# NARRATIVE RESPONSES - PLAN CORRECTIONS REPORT (HPB21-0481)

**PLAN ADDRESS:** 1901 Collins Ave  
Miami Beach, FL 33139-1911

**DESCRIPTION:** New residential tower.

**Sub: Shore Club, 1901 Collins Avenue, Miami Beach, FL**  
**RE: Response to HPB Plan Corrections Report of 11/24/2021**

**Exhibit A – Cromwell Lobby, 1940.**

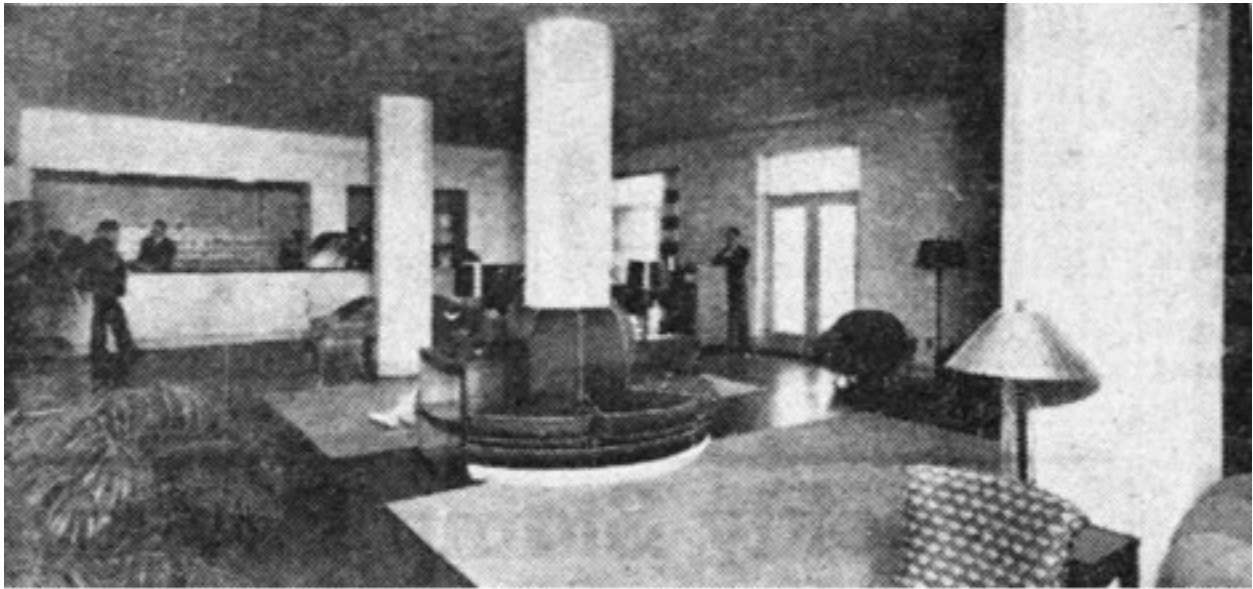
Comment 6.2.a. of the report states, "Staff recommends that the Cromwell Hotel lobby be substantially restored consistent with available historical documentation."

There is only one photograph that depicts the historic lobby space of the Cromwell. Please see Exhibit A attached. The Cromwell sat vacant for approximately 15 years and underwent several unsuccessful attempts at renovation before the 1999-2001 project. Please see Exhibit B for a photo of the gutted lobby space.

In our expert professional opinion, no contributing features remain in the space, other than the structural elements of the columns. Due to the lack of features and the modified configuration, we recommend a compatible interpretation that would reference and interpret the original lobby space based on the single available photo.

**1** PROPOSED OVERALL LEVEL 1 FLOOR PLAN  
 SCALE: 1" = 50'-0"

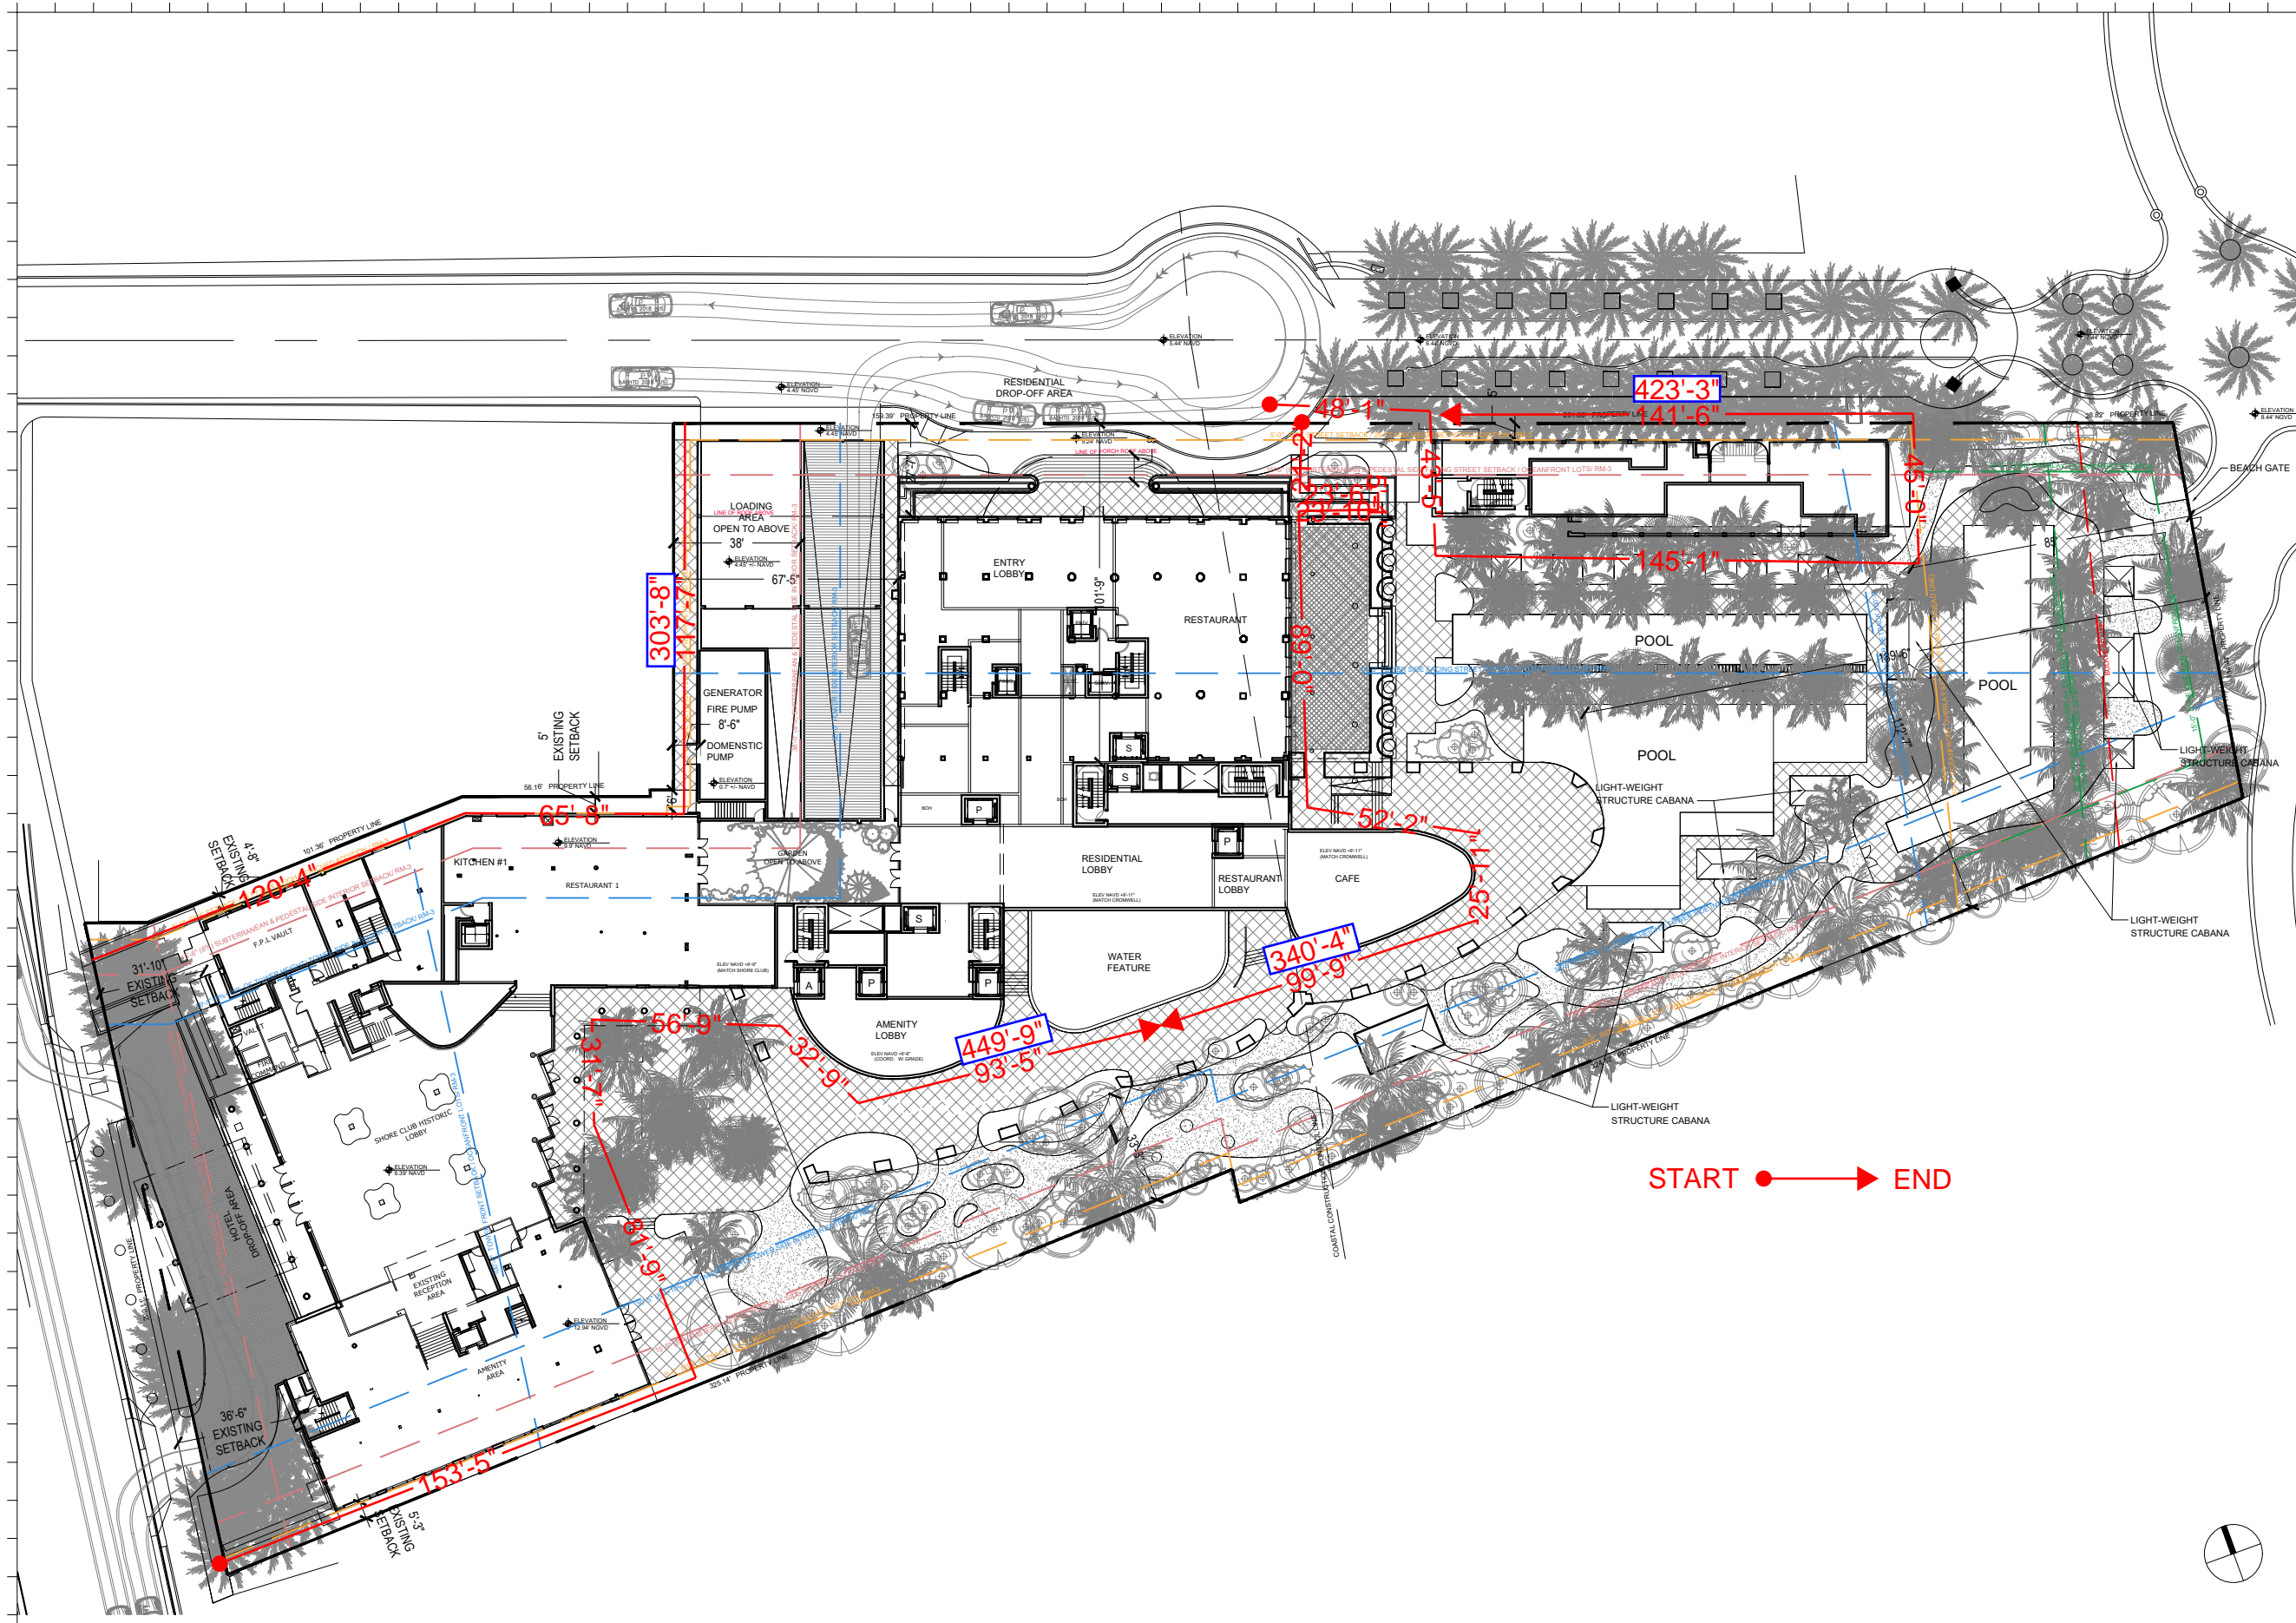
- Fire department access roads shall be provided such that any portion of an exterior wall of the first story of the building shall be located no more than 150-ft or 450-ft for sprinklered buildings from a fire department access road as measured from an approved route around the exterior of the building (FFPC 18.2.3.2.2.1).

**The exterior wall of the building's first story complies, refer to site access plan attached.**
